# PHILADELPHIA ELECTRIC COMPANY

April 4, 1983

Docket Nos.: 50-352  
50-353

Subject: Limerick Generating Station, Units 1 and 2  
Reference: Letter A. Schwencer to E. G. Bauer, Jr., dated  
February 7, 1983  
File: GOVT 1-1 (NRC)

JOB NO. 8031  
EMERGENCY SERVICE WATER SYSTEM  
P&ID 8031-M-11, SHEET 1, REVISION 18

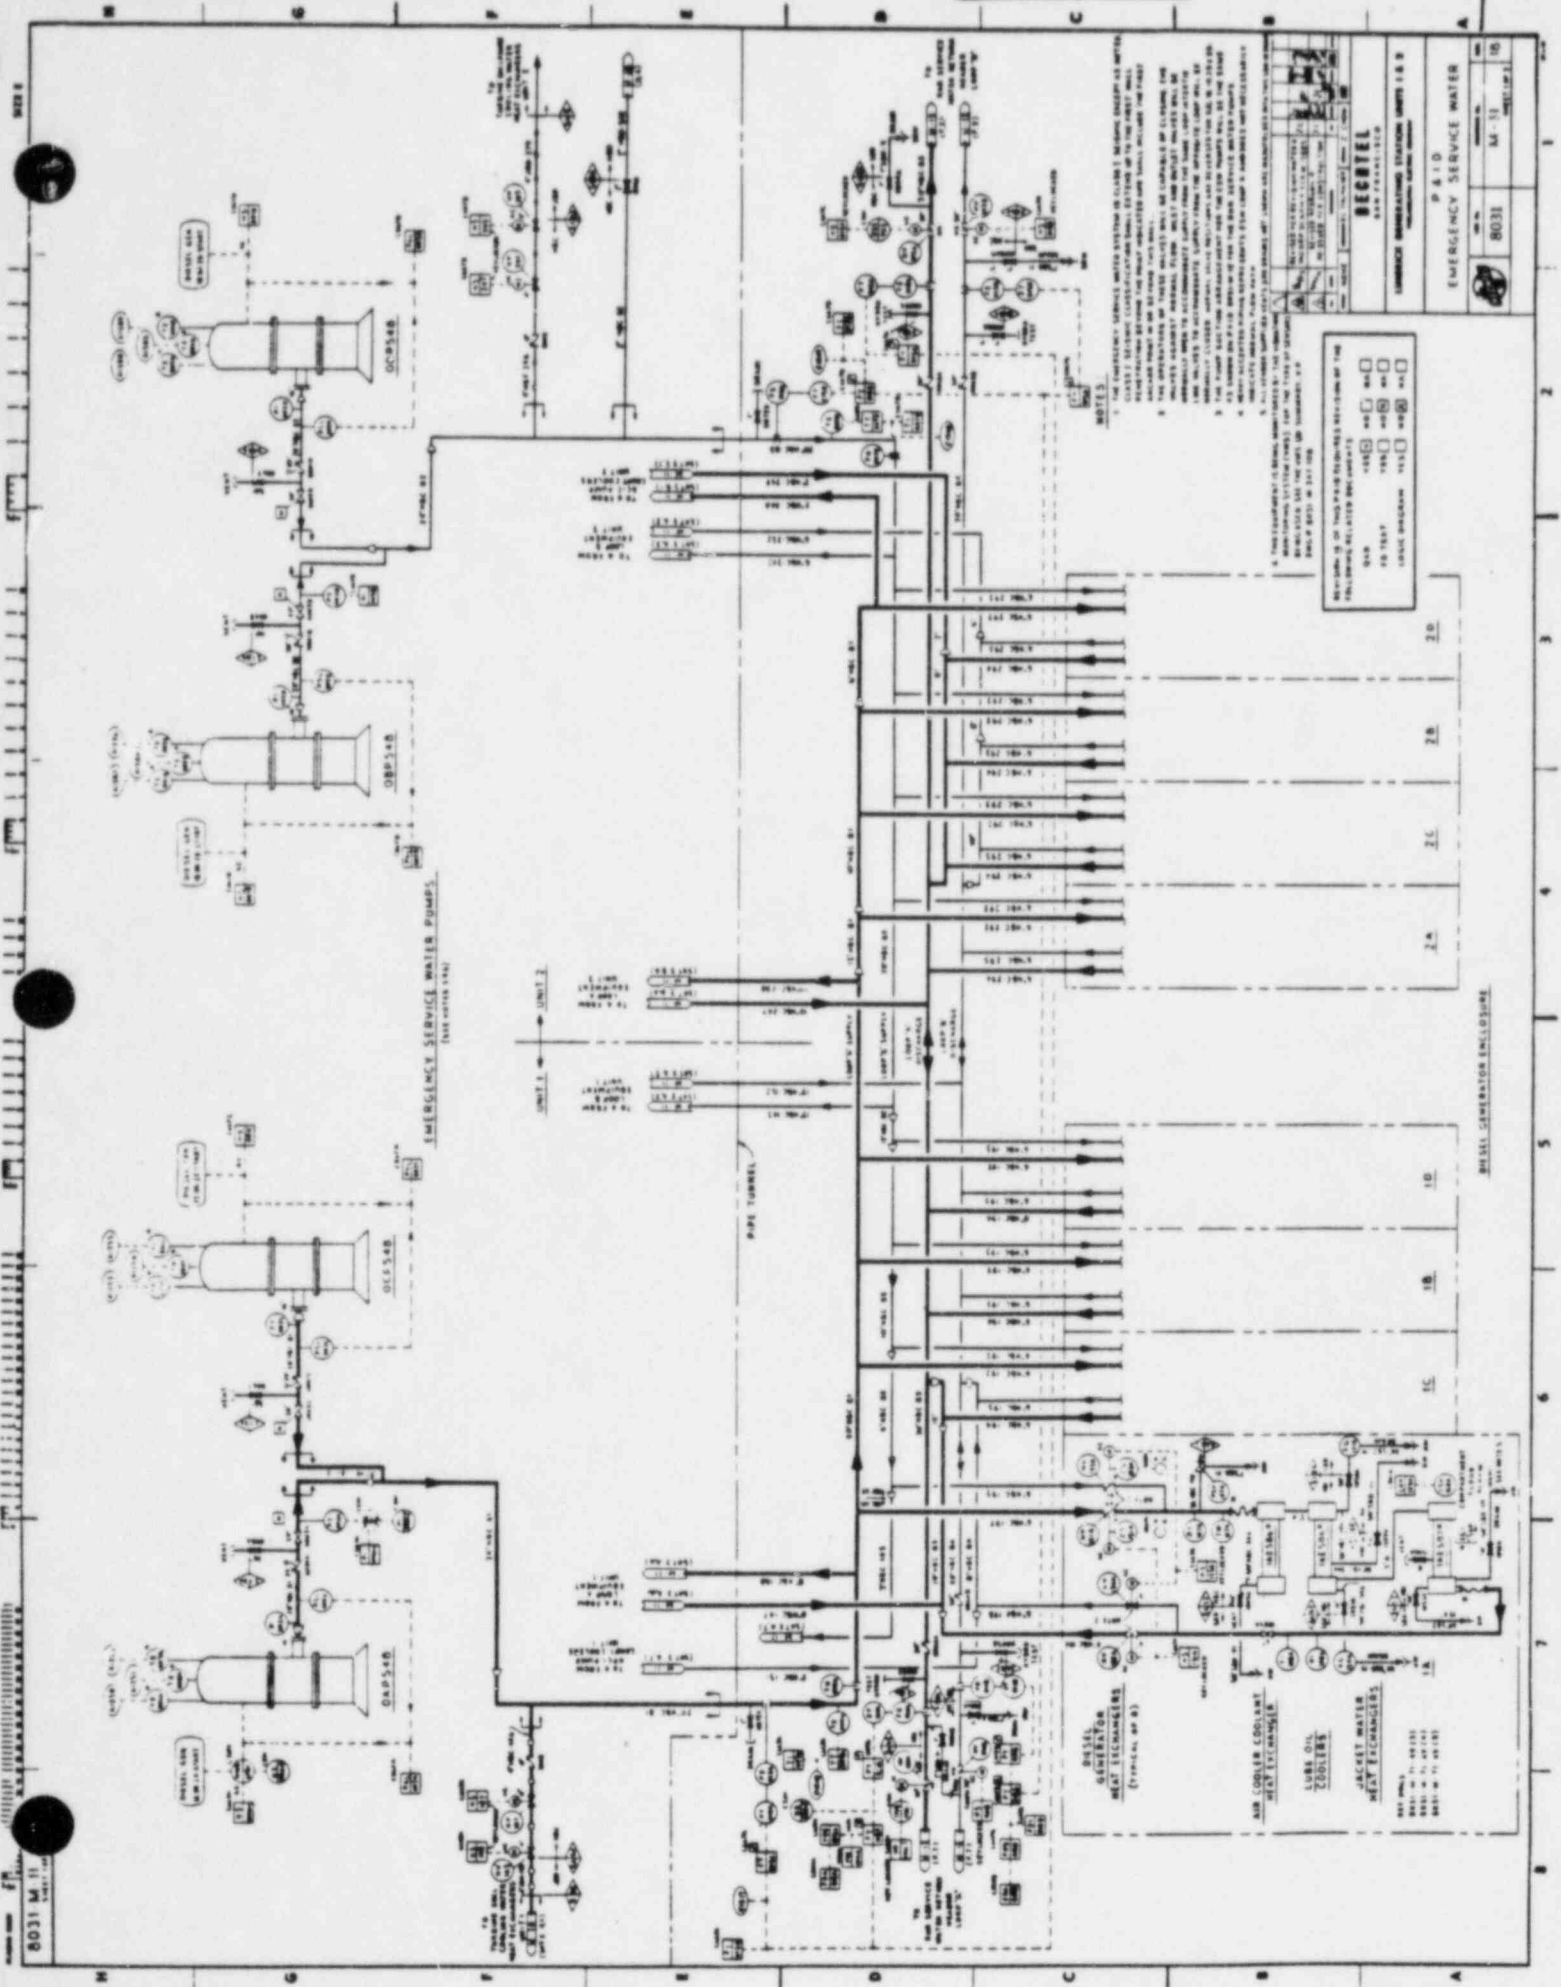
QUESTION NO. 11  
(Table 3.2-1)

Sheets 1, 2 and 3 of Figure 9.2.2 indicate the parts of the Emergency Service Water System that are Seismic Category IIA. Non-Seismic Category I drain and vent lines and capped ends extending from Seismic Category I piping are Seismic Category IIA downstream of the last isolation valve.

ADDED DRAIN VALVES 11-0072A&B PER  
FCR-M-13,885.

LIME ROCK GENERATING STATION  
 UNITS 1 AND 2  
 FINAL SAFETY ANALYSIS REPORT  
 STANDBY DIESEL GENERATOR AND  
 PLANT FUEL OIL SYSTEMS  
 FIGURE 8-2-4 sheet REV 12, NOV 80

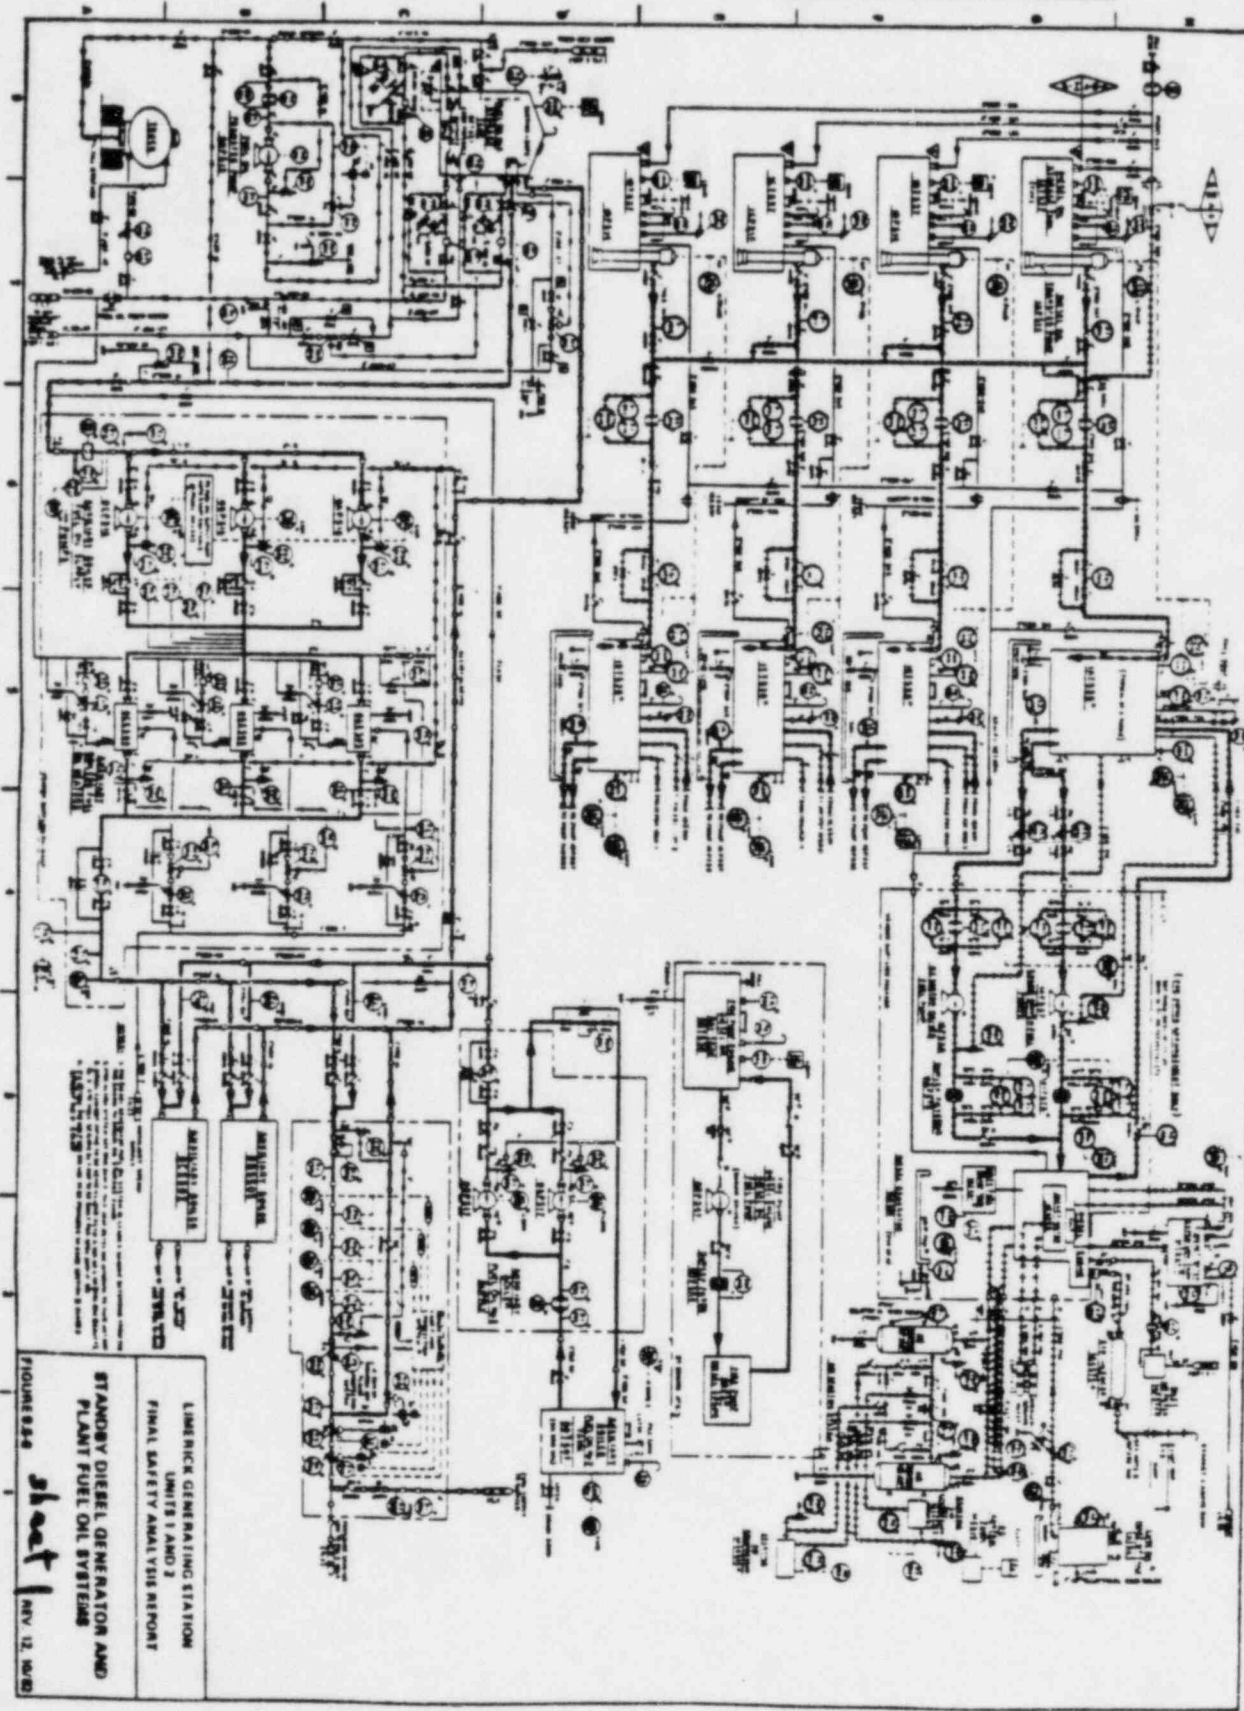
QUESTION 430.75 (Sections 3.2, 9.5.4, 9.5.5, 9.5.6, 9.5.7, 9.5.8)

Diesel generator auxiliary systems piping and components are classified in the FSAR text and Table 3.2.1 as conforming to ASME Section III Class 3, ANSI B31.1, or manufacturer's standard. It is not entirely clear where the respective classifications begin or end. In any event, this is not acceptable. We require the entire diesel generator auxiliary systems to be designed to ASME Section III Class 3, or Quality Group C, in accordance with Regulatory Guide 1.26. Revise your FSAR accordingly. Also, provide the industry standards that were used in the design, manufacture, and inspection of the diesel engine mounted piping and components. Revise the appropriate P&IDs to show where quality group changes occur.

- a. Fuel oil system (Figure 9.5-8)
- b. Cooling water system which includes the jacket water cooling loop and the air cooler coolant loop (Figure 9.5-9)
- c. Starting system (Figure 9.5-10)
- d. Lubrication system (Figure 9.5-11)
- e. Combustion air intake and exhaust system (Figure 9.5-12)

FIGURE 3.9-9

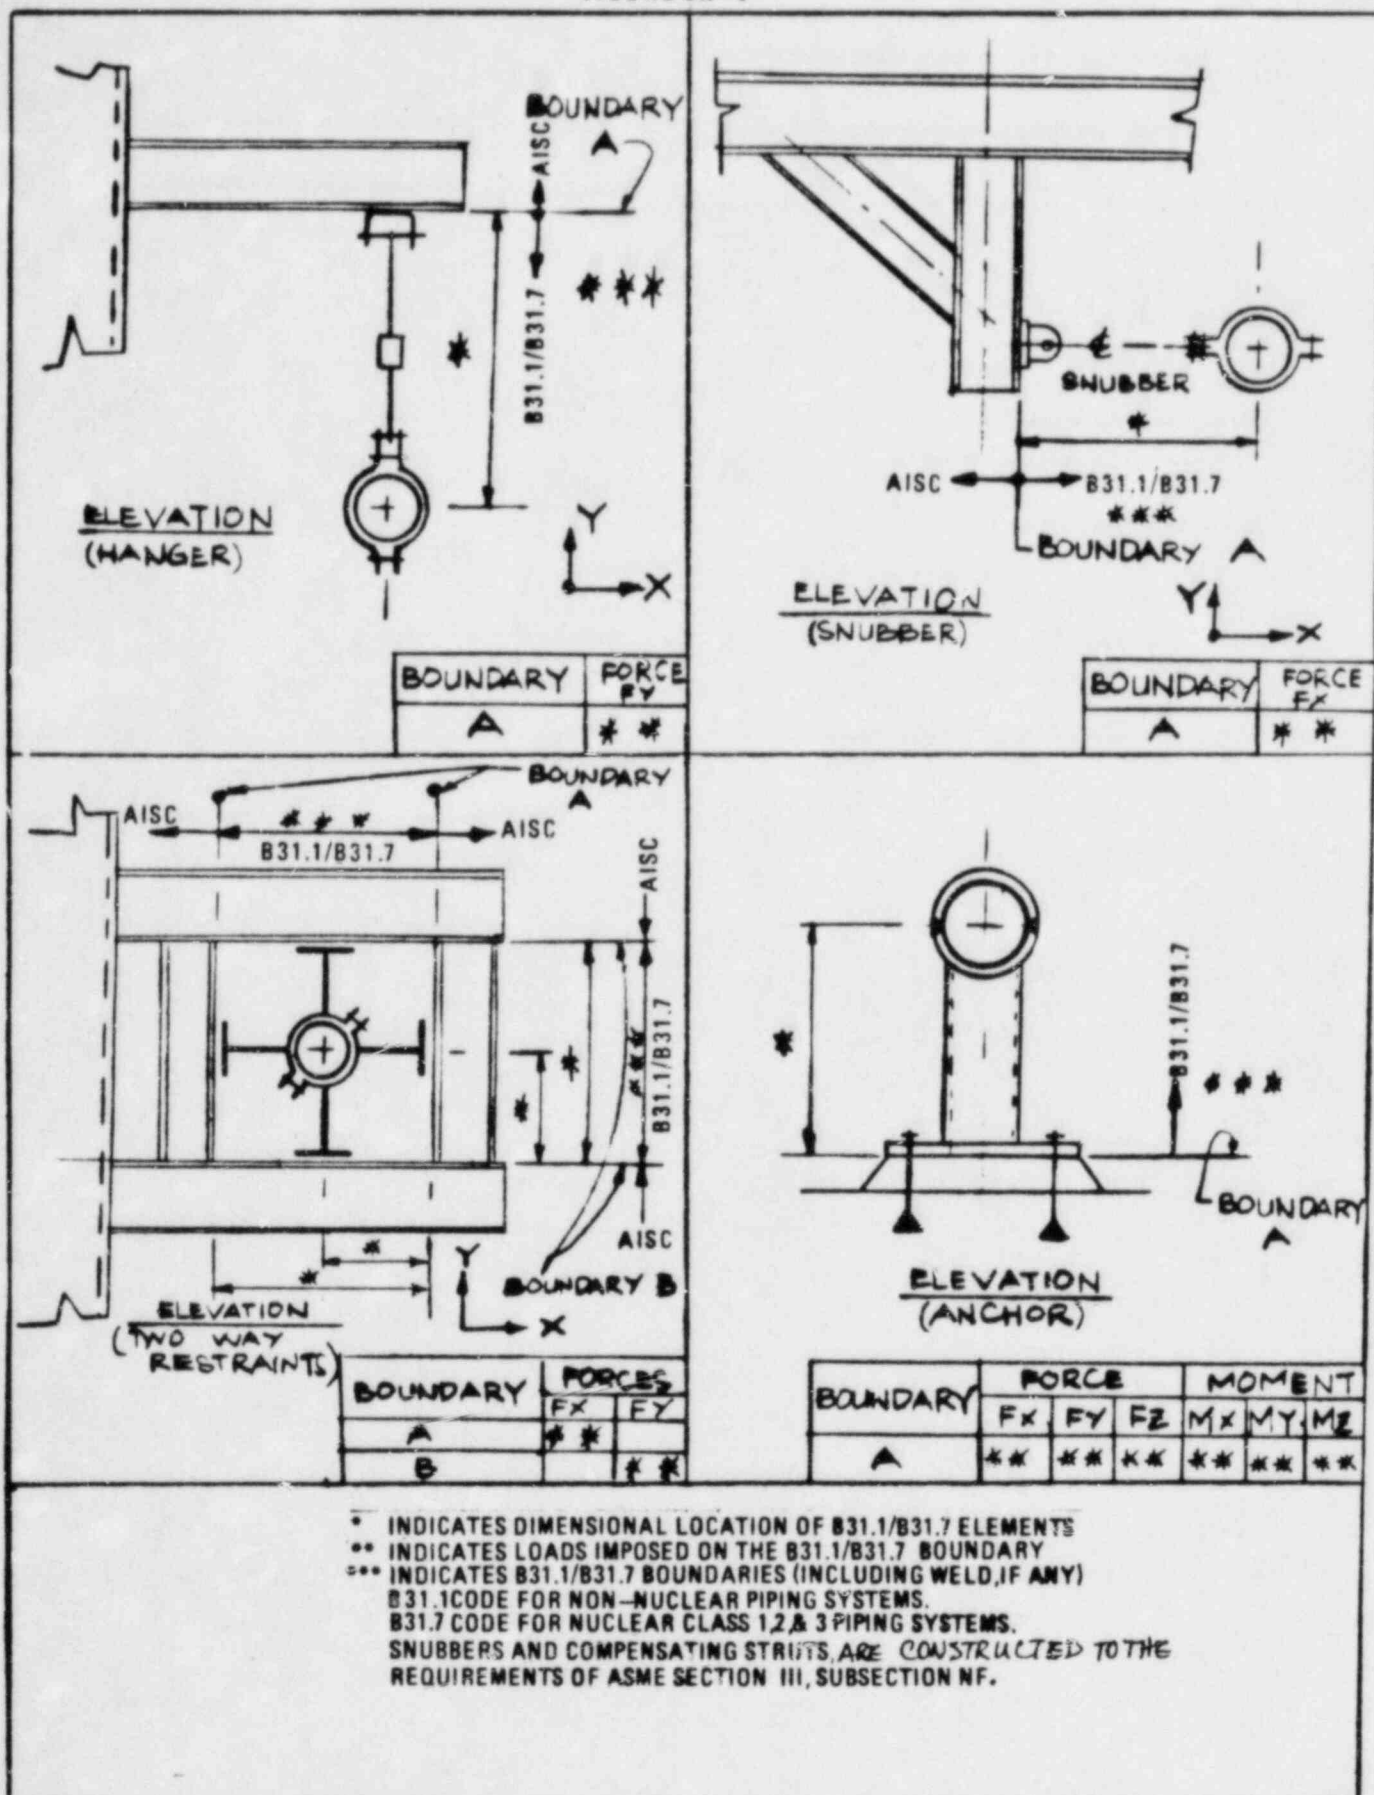
Provide a graphic summary of your interpretation of Subsection NF boundaries.

Section 3.9.3.4.2 is revised and Figures 3.9-9 and 3.9-10 are added to show the jurisdictional boundaries for the pipe supports.
